OIL CONSERVATION COMMISSION
Albuquerque DISTRICT

for the MERRION & DAYLESS Navajo H #13 15-13-29N-14W
Operator Lease and Well No. Unit, S-T-R

Enclosed please find our application for approval of salt water disposal into the subsurface reflecting a change of plans.

APPLICATION TO DISPOSE OF SALT WATER BY INJECTION INTO A POROUS FORMATION

Wellbore Diagram

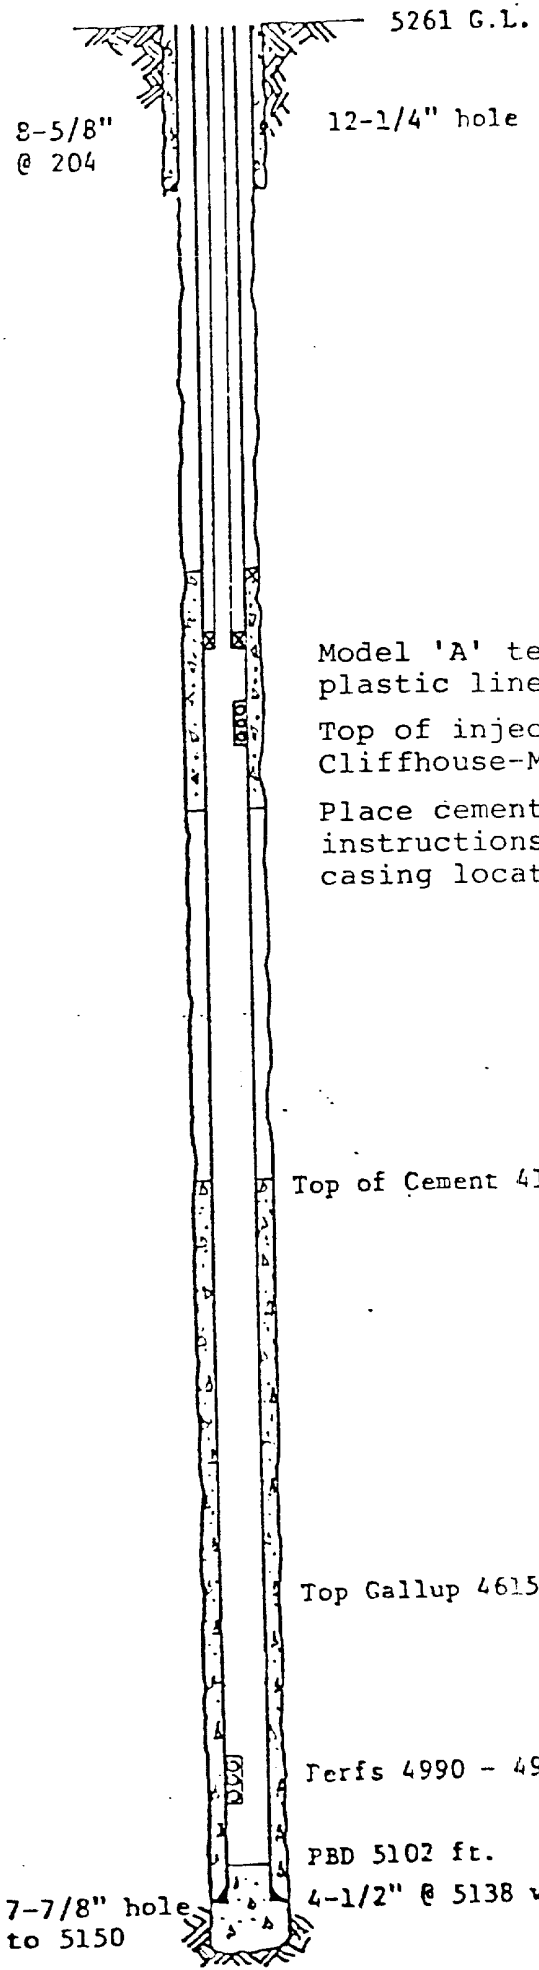
We propose to change the injection zone from the Gallup to the Cliffhouse Mesa Verde at 2490-2520 feet. Cement will be squeezed across this zone as instructed by the District Engineer.

Place cement across Cliffhouse and squeeze per instructions from District Engineer when hole in casing located.

Approve
